CITY OF ALBUQUERQUE

RE: **1st Nations Community Healthsource**
5608 Zuni SE
Grading and Drainage Plan
Engineers Stamp Date: 1/17/18
Drainage File: L18D047

FIRST NATIONS COMMUNITY HEALTHSOURCE
HEALTH INFRASTRUCTURE
IMPROVEMENT PROJECT

SITE GRADING AND DRAINAGE PLAN
1" = 20'-0"

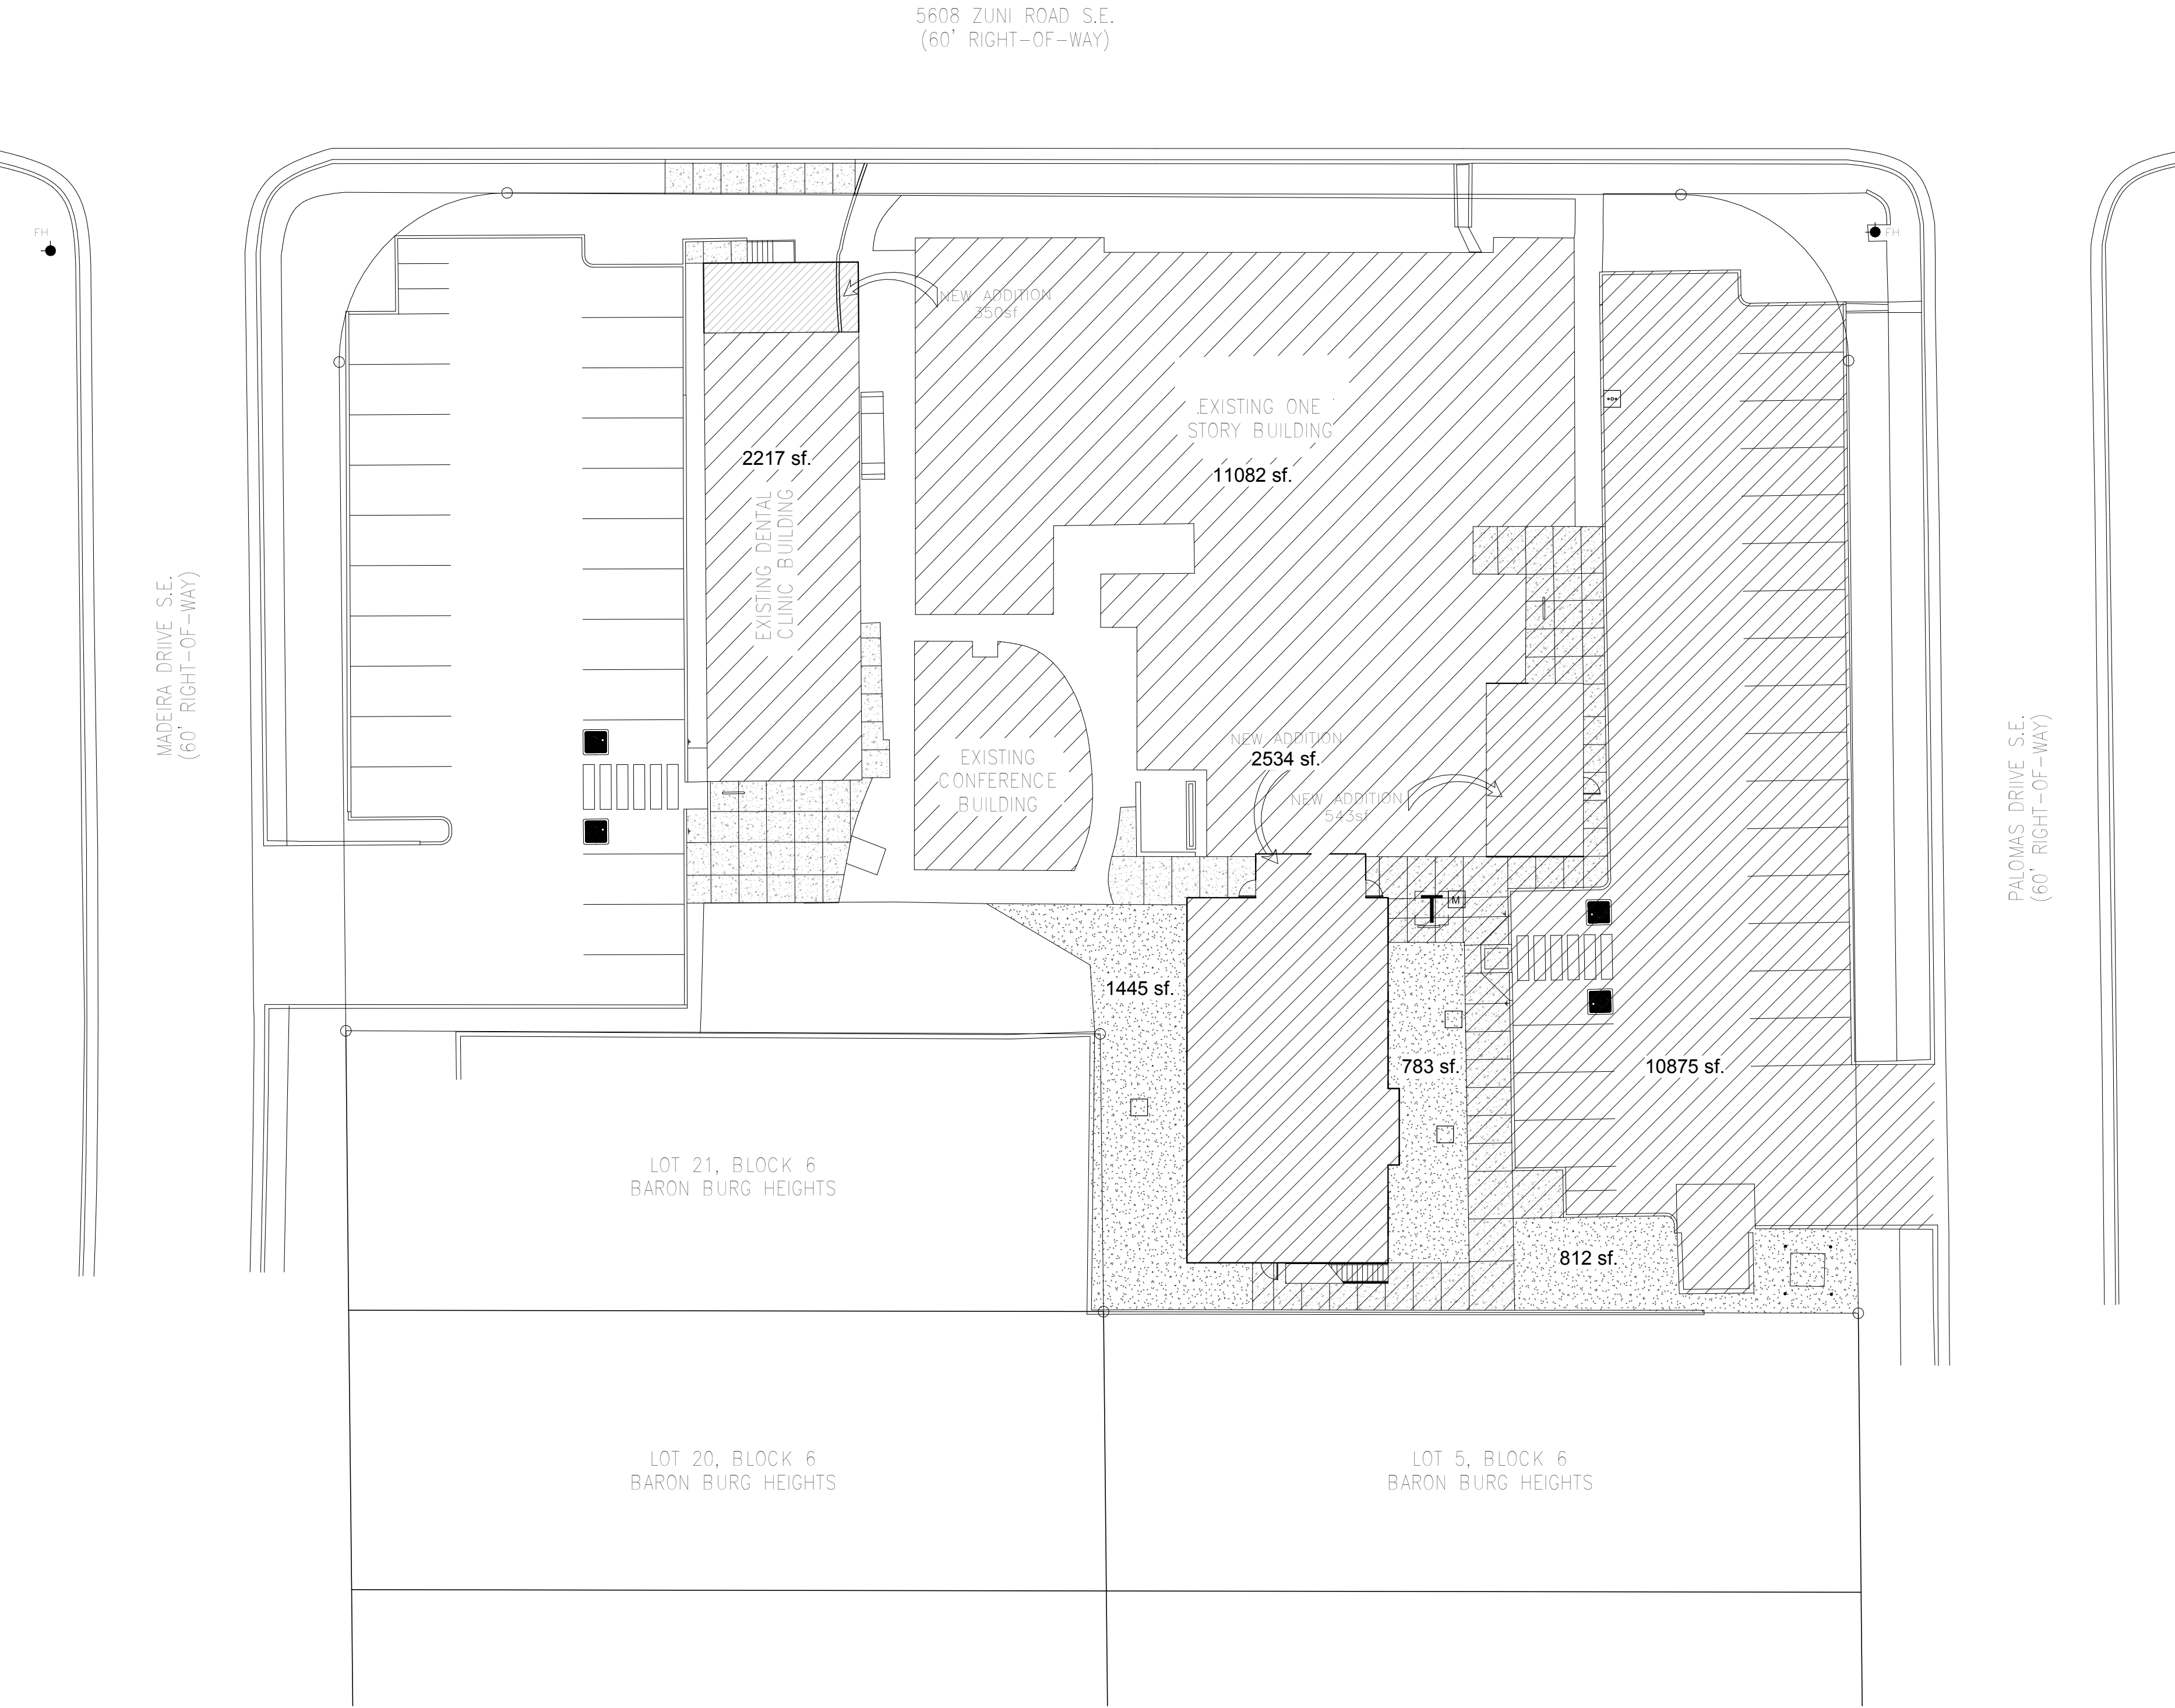
Based on the information provided in your submittal received 1/22/18, the Grading and Drainage Plan is approved for Building Permit. Geotextile fabric is also recommended around the gravel pack to reduce maintenance of the French drains.
